***ADDENDUM***  
***TO***  
***FUNCTIONAL SERVICING REPORT***

**HILLSBURGH HEIGHTS INC.**  
**PROPOSED RESIDENTIAL SUBDIVISION**

**5916 TRAFALGAR ROAD NORTH**

# **1. RESPONSES TO THIRD SUBMISSION COMMENTS RELATING TO STORMWATER MANAGEMENT**

**SEDIMENT DRYING AREAS**  
1:1000

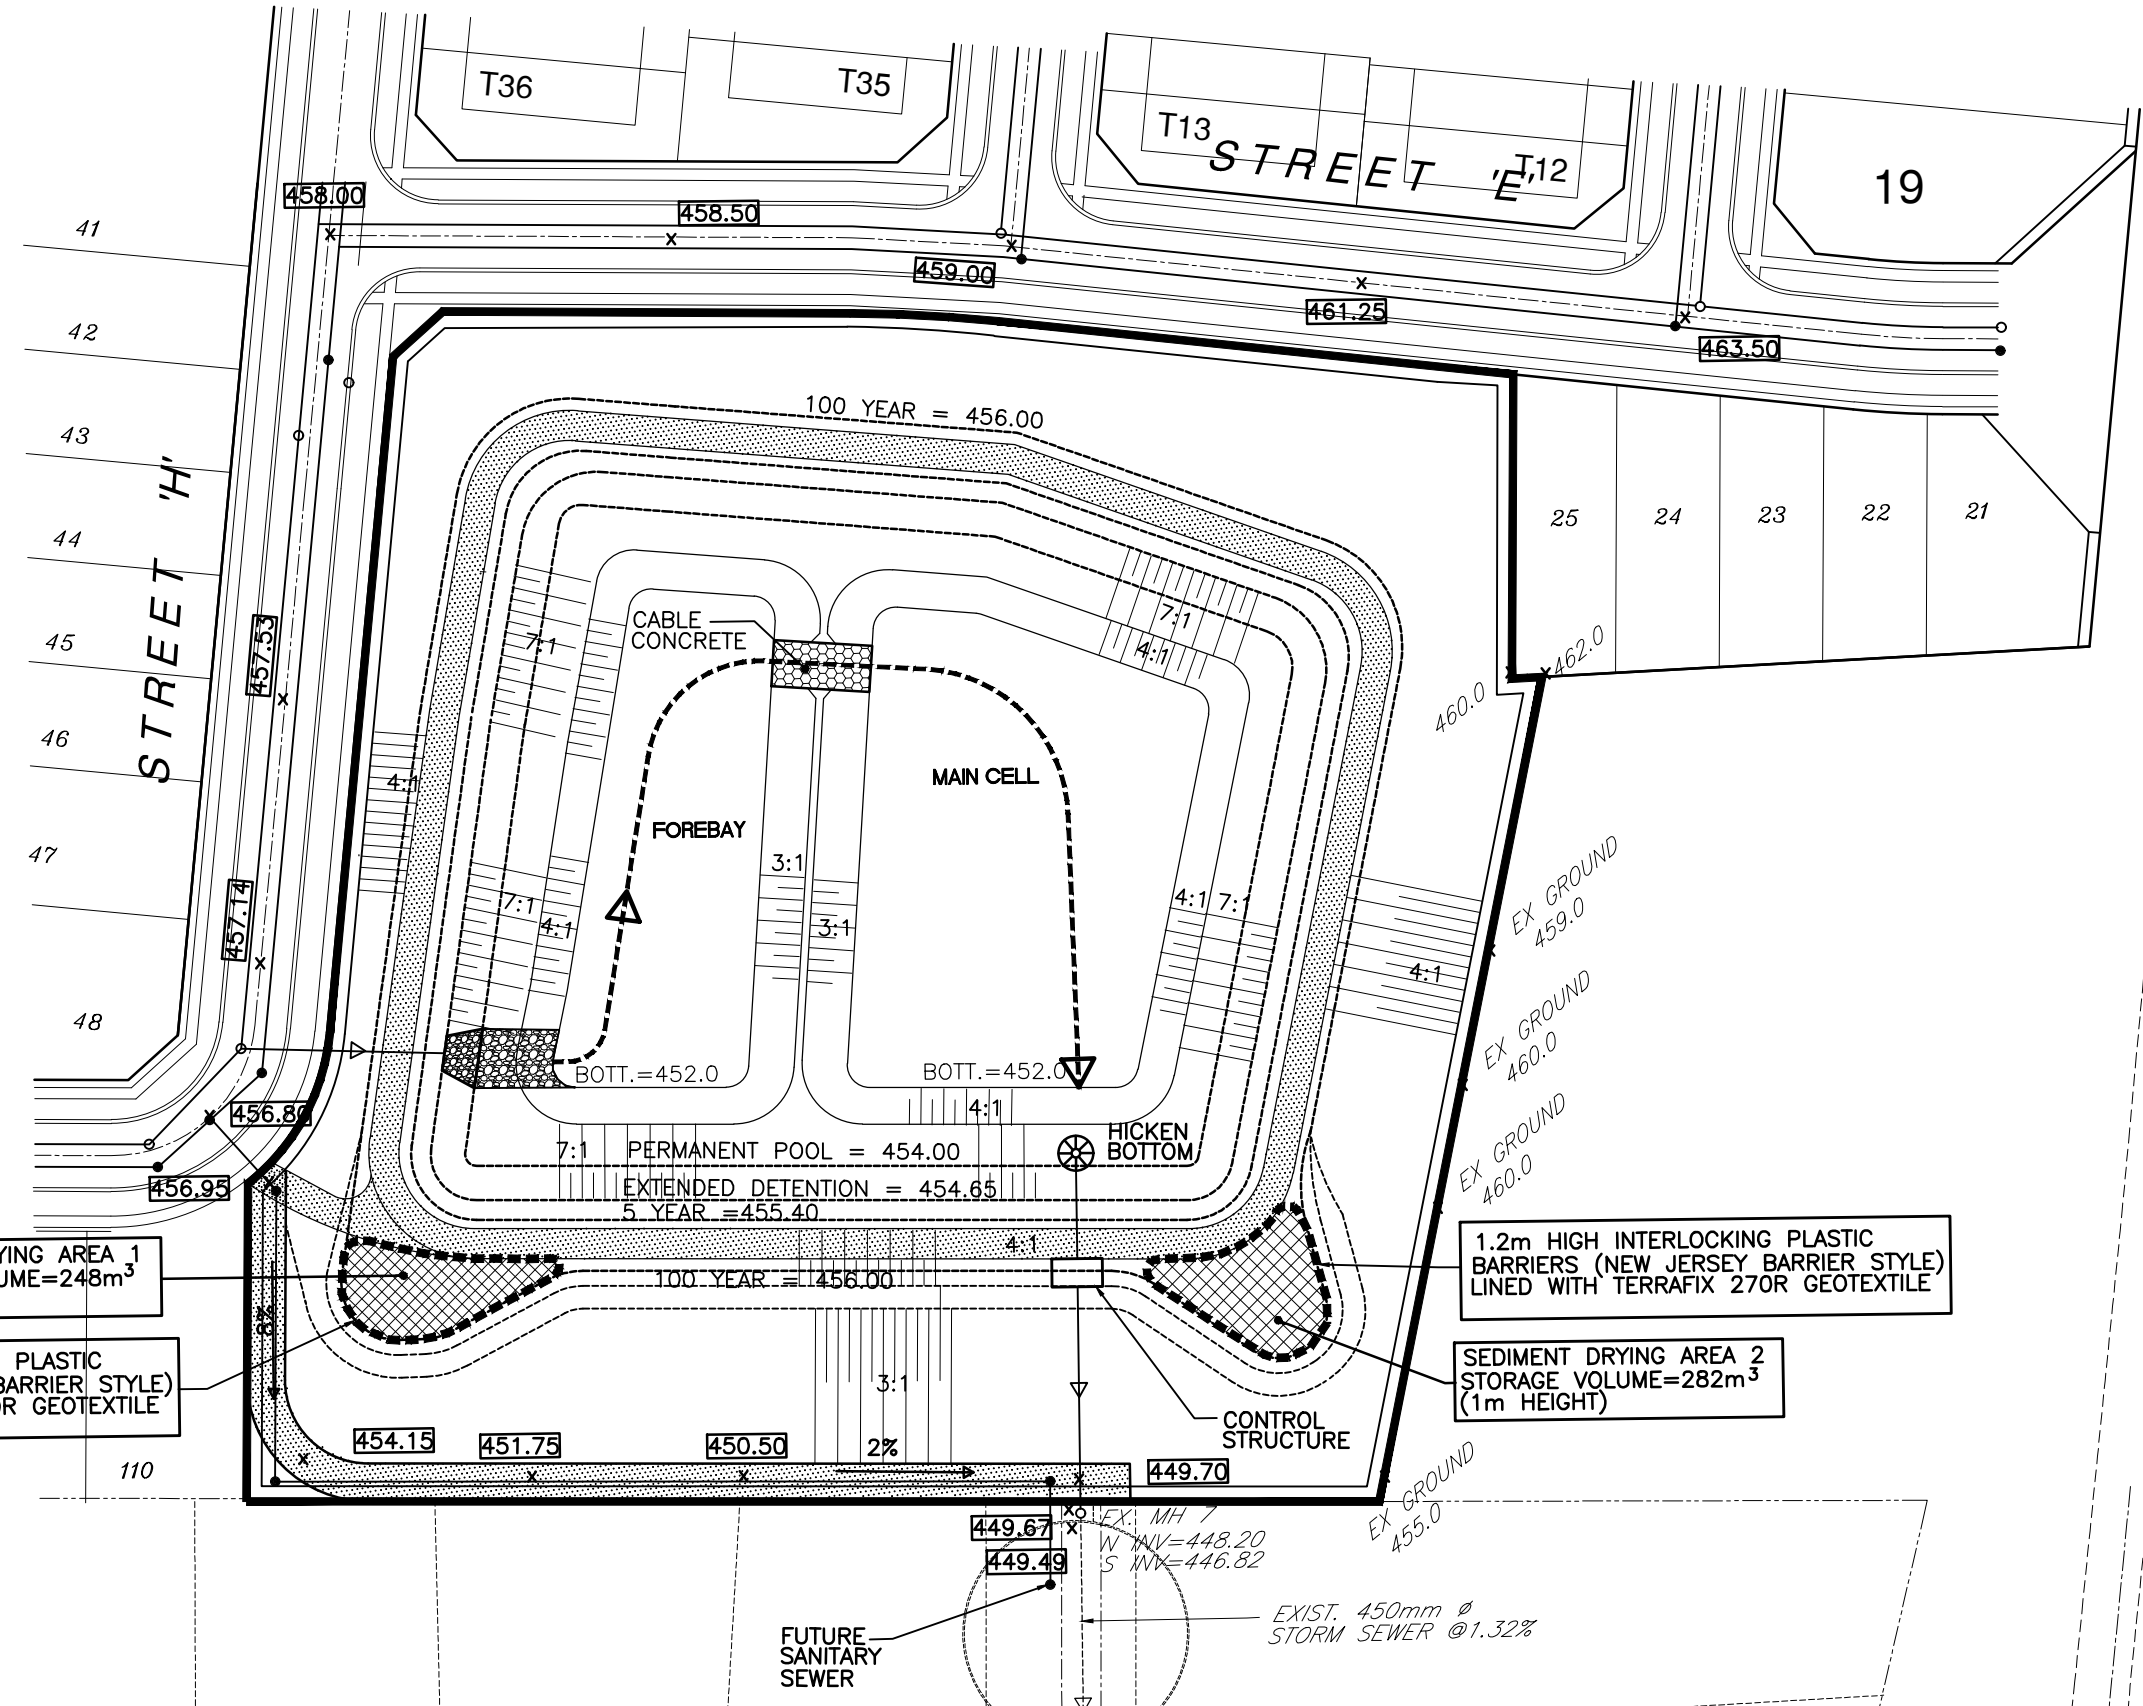
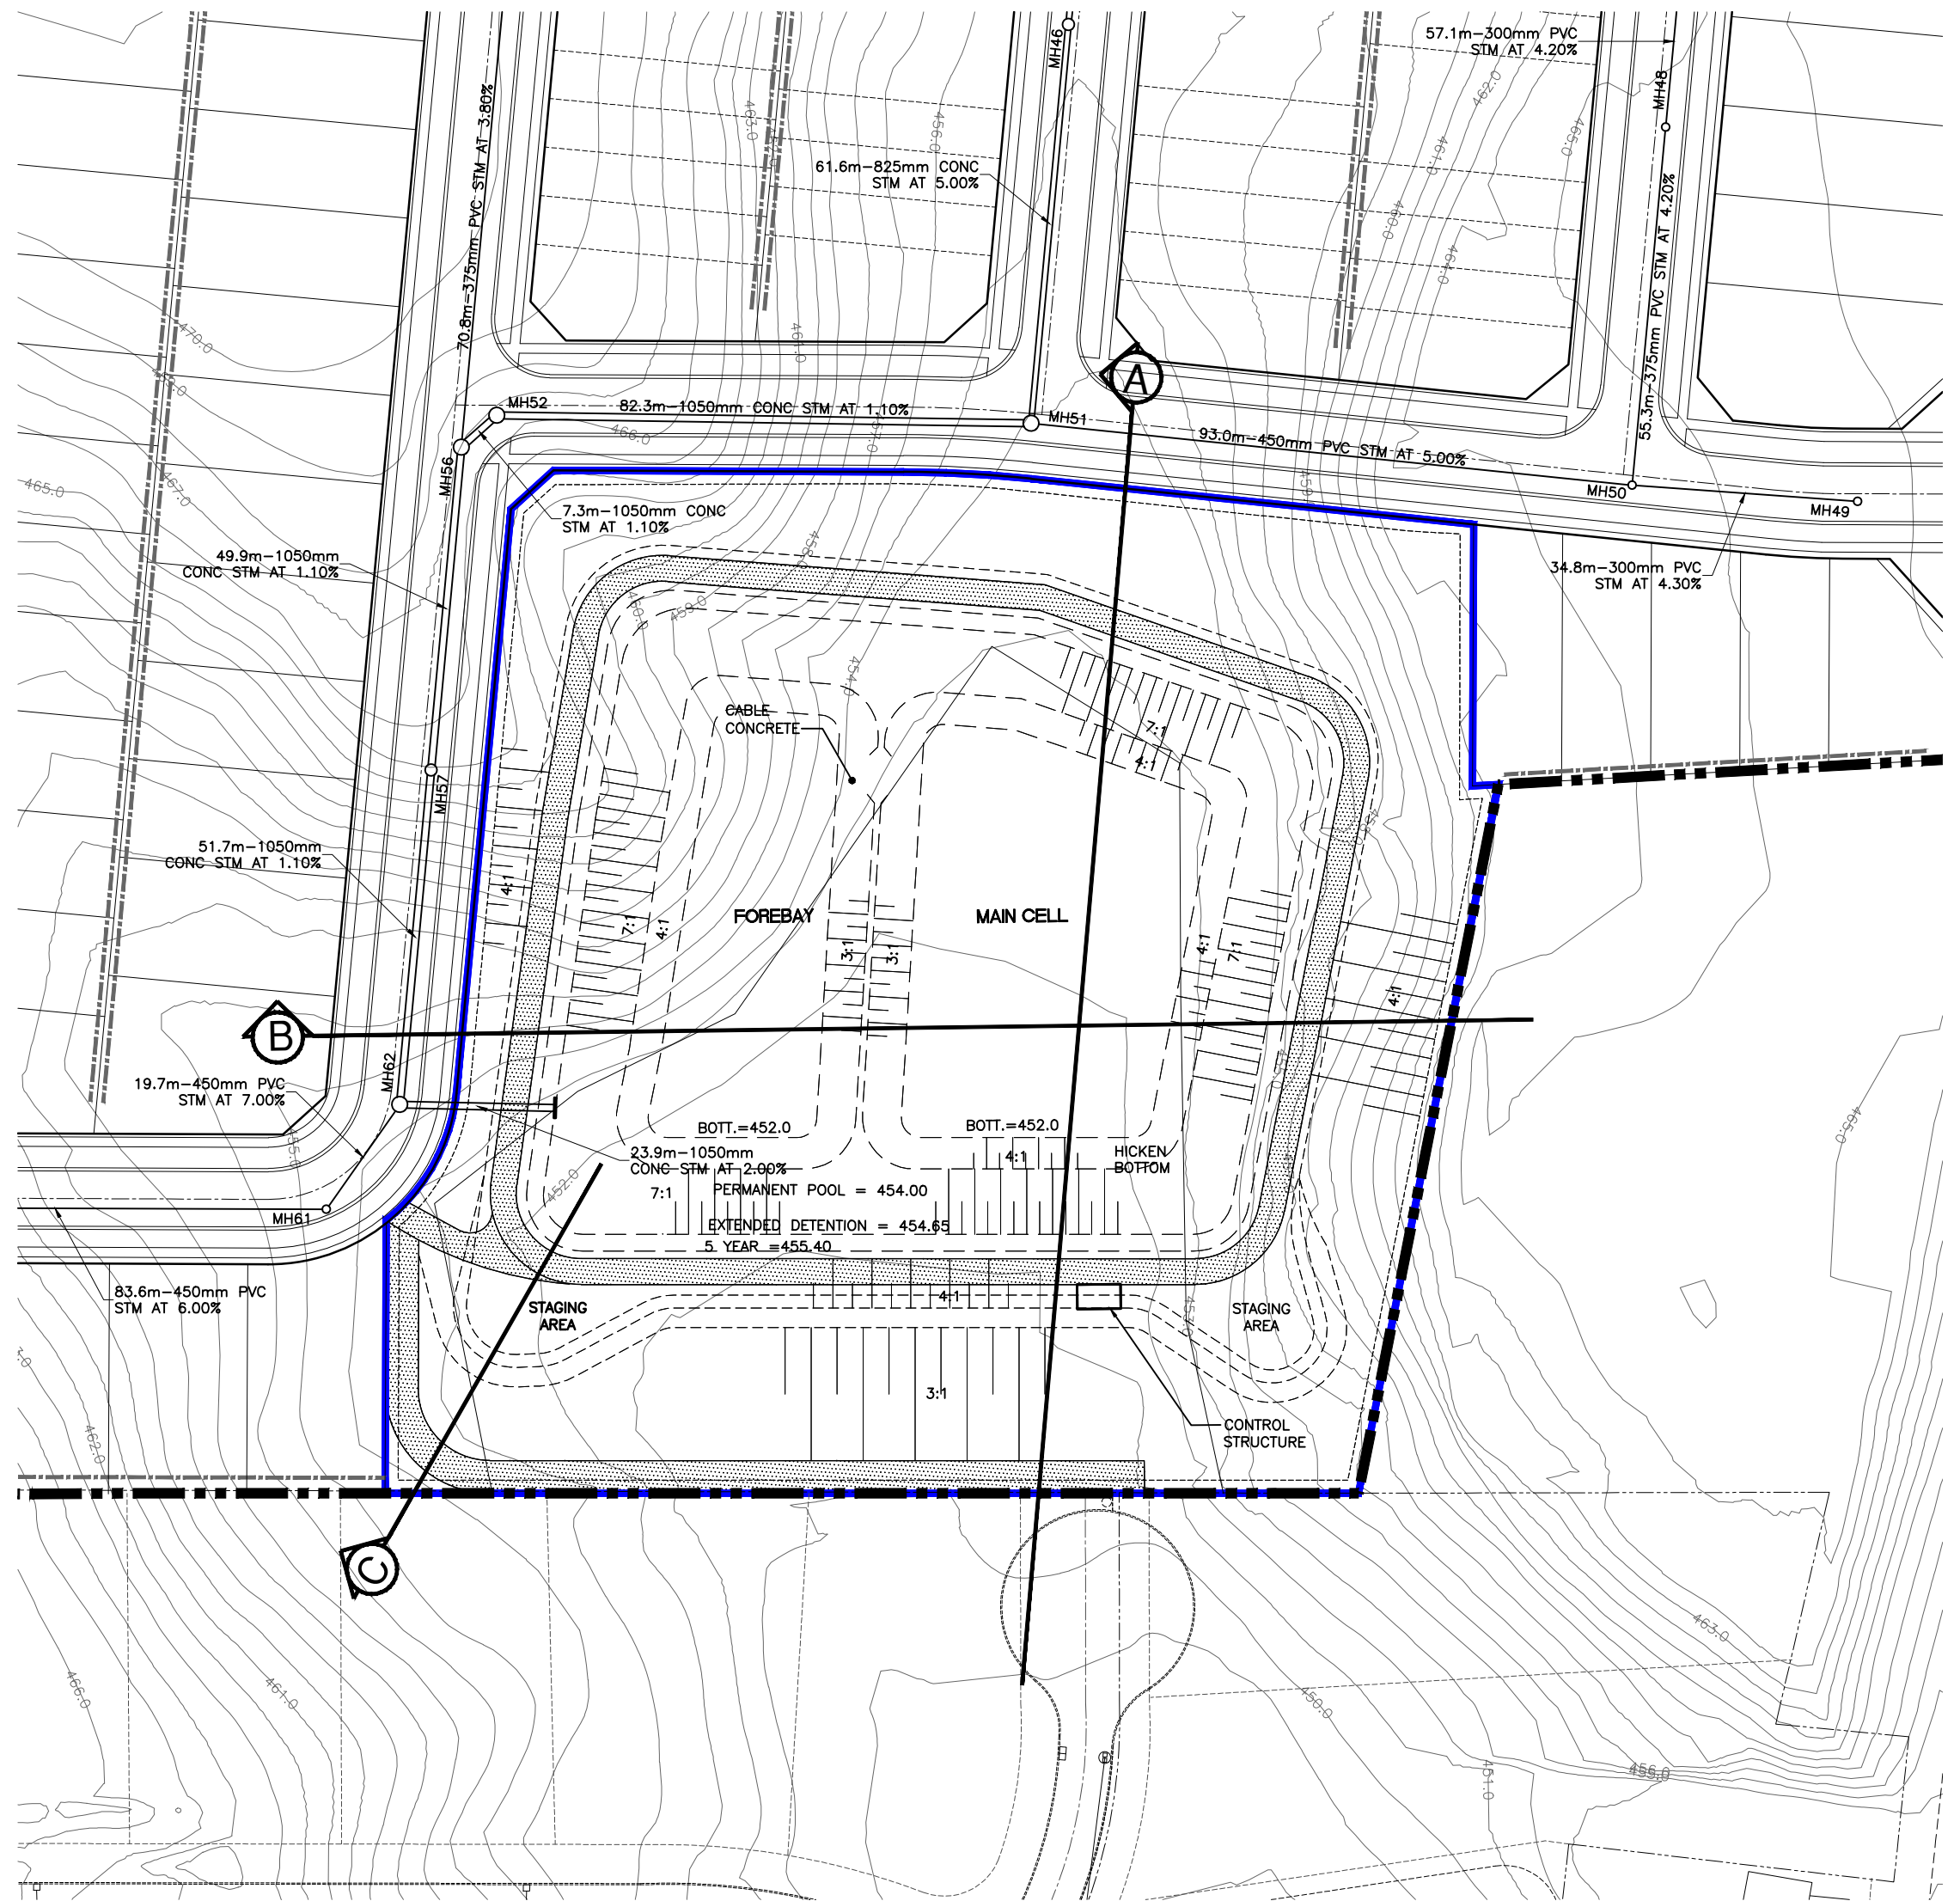
### **13. Sediment Drying Areas in SWM Ponds**

Notwithstanding that sediment drying areas are not used by Contractors for removing sediment from SWM ponds, as required by the Town sediment drying areas are shown on SWM Pond Drawing SWM-1 Rev. 3 and SWM-2 Rev. 3.

Refer to the attached Appendix II for the sediment drying areas storage volume calculations. A storage area of 530m<sup>2</sup> is provided in SWM Pond No. 1 (east) and an area of 467m<sup>2</sup> is required. A storage area of 731m<sup>2</sup> is provided in SWM Pond No. 2 (west) and an area of 458m<sup>2</sup> is required.

Storage Capacity as per Drawing SWM-1 =  $530\text{m}^3$  (1m height)
